Valve Cover Oil Leak at T Joint
CHU, CXU, GU, PI, AN, GR

FSB 211-003, Valve Cover Oil Leak at T Joint

(October 2021)

New Seal Pattern

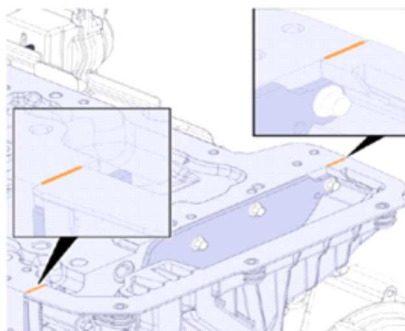
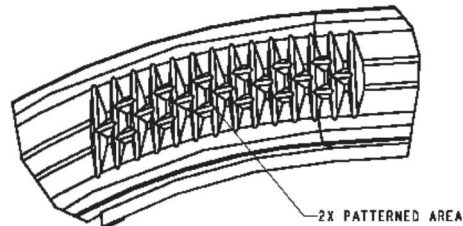
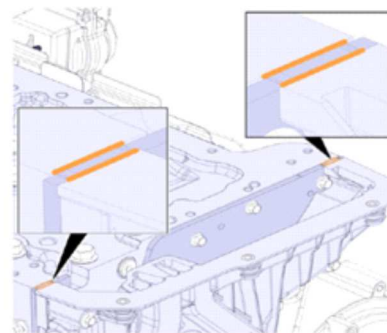
With the introduction of the integrated timing plate seal and the one-piece upper timing cover seal, the sealing procedure for the lower valve cover frame have changed. Testing has confirmed that if too much sealant is applied it can weaken the gasket and cause an oil leak over time. The images below outline the gasket pattern changes. The below procedures **MUST** be followed.

- The lower valve cover frame gasket is NOT to be reused. Always replace the gasket anytime the lower valve cover frame is disturbed (i.e. removed).
- Before applying sealant **BE SURE** the surface is **completely** free of grease, oil, and old sealant. Any oily or greasy residue will prevent the sealant from properly adhering. The use of a cleaning agent/solvent will be required (i.e. Brake-Clean or equivalent).
- When applying the sealant follow the procedure in IMPACT. Use 2 beads of sealant per side at a thickness **no larger than** 2mm (.078 in). See image below. In this joint, too much sealant causes issues.
- Install the lower frame with new gasket, upper valve cover, and torque to specification within 20 minutes of sealant application.
